CELMV-ED-PG (CEOW-EP/21 Aug 89) (1105-2-10c) 1st End Mr. Bardwell/ts/5925
SUBJECT: Lake Pontchartrain, Louisiana and Vicinity, High Level Plan, Design
Memorandum No. 18 - General Design, St. Charles Parish, North of Airline
Highway

The following gives our response to the CECW-EP basic letter. Responses are keyed by reference to paragraphs in the basic letter.

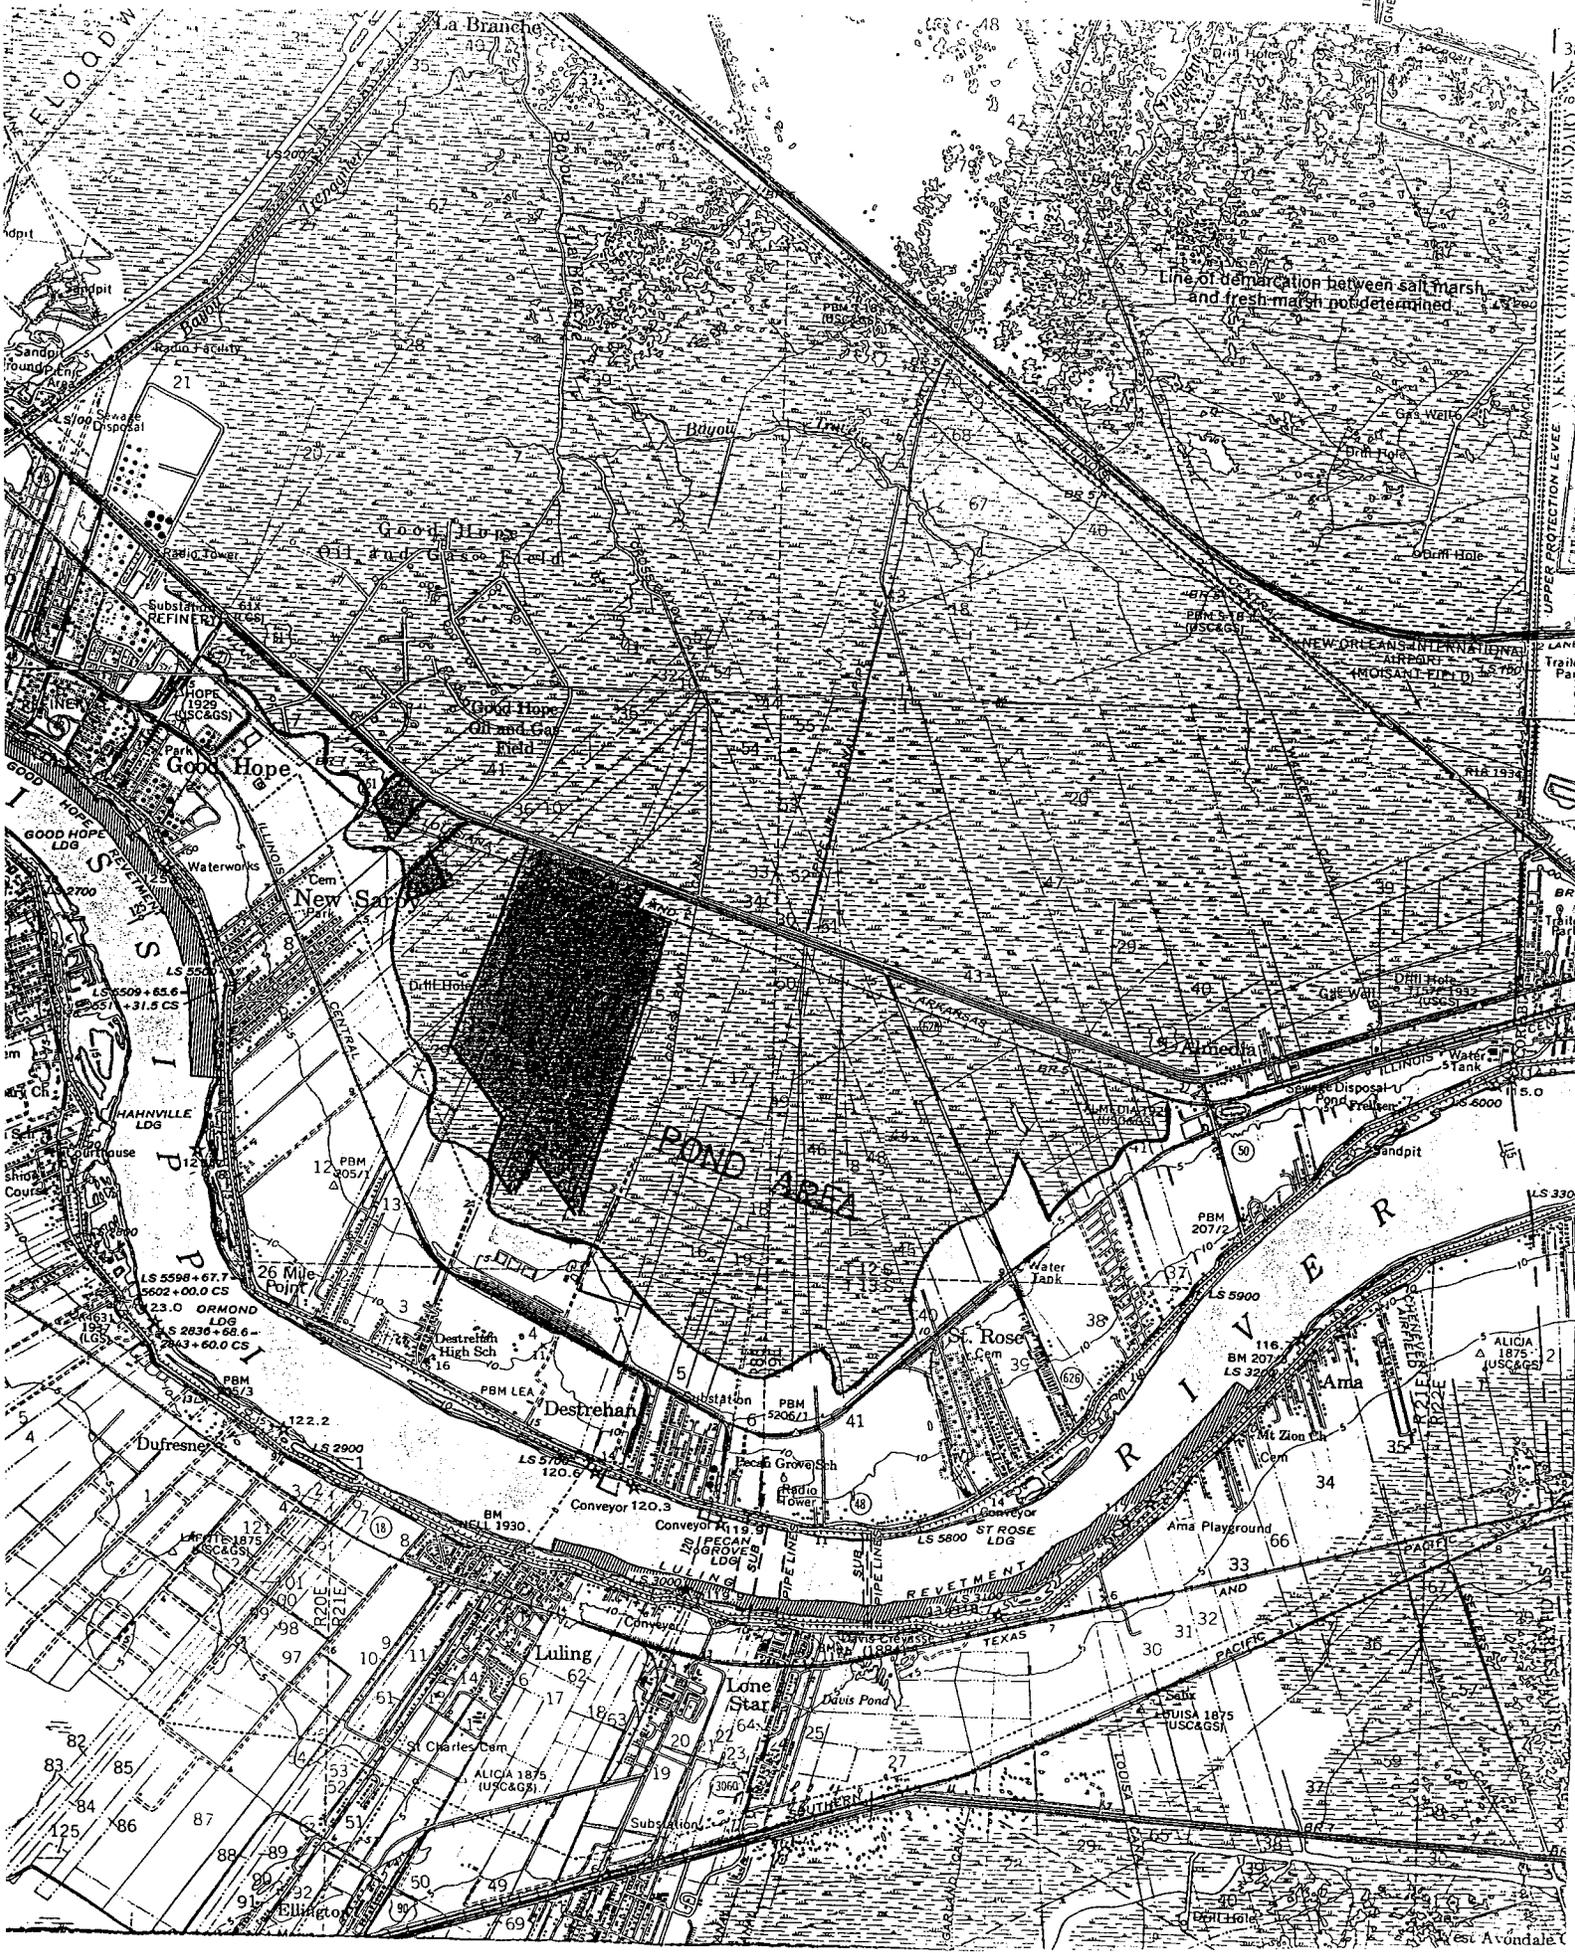
2. Basic memorandum, paragraph 8 and corresponding response in second endorsement. The ponding areas must be identified. If the ponding area mapping was not included in the July 1984 reevaluation report, they must be included in this report or in the operations and maintenance manual of the project. Ponding areas, if not acquired by fee or easement, must be identified as a basis for the enforcement of local cooperation item in paragraph h. on page 7 of the report which is as follows:

4. Unless these areas have been identified by maps, the above item of local cooperation (which is one frequently included in levee projects) would not be enforceable. This region has a history of encroaching on ponding areas or of allowing development in such areas. Clear delineation of the ponding area is necessary both to enforce this local assurance and to

preclude future Federal projects protecting new development
which may occur within the ponding area. The mapping would also
serve as a regulatory control for determining flood insurance
eligibility.

The 1984 reevaluation report did not depict the ponding area south of the proposed levee. We are enclosing a copy of the quad-sheet for the area and have labeled the ponding area as directed. As can be seen, with the exception of the blocked out areas, the entire ponding area is a wetland and its development is regulated by existing Federal, state and local permitting authority. In developing the stage-storage curves for the area, we assumed no storage in the blocked out areas since they were previously leveed or filled. The District Engineer will weigh in his decision the potential impacts due to reduced storage capacity that any proposed developmental encroachments might have before issuing or denying a permit in the ponding area.

As we indicated in a previous endorsement, the St. Charles Parish Council has filed for a permit to construct four pumping stations. These stations are intended to supplement the approved gravity drainage structures. Operation of the pumping stations as proposed in the permit application is intended to reduce ponding requirements during times that the gravity drainage structures gates are closed due to high lake stages caused by hurricanes or tropical storms. The proposed permit will not allow the pumps to be used to drain the wetland area on the protected side of the levee. Based on our meetings with Federal and state resource agencies and the receipt of no adverse public comments during the permit review process, issuance of the permit appears likely. Construction of the pumping stations along with regulation of development within the ponding area will fulfill local interest obligations under item h. of local cooperation agreement. We are confident that no additional easements, regulations, or institutional constraints on the area are necessary.
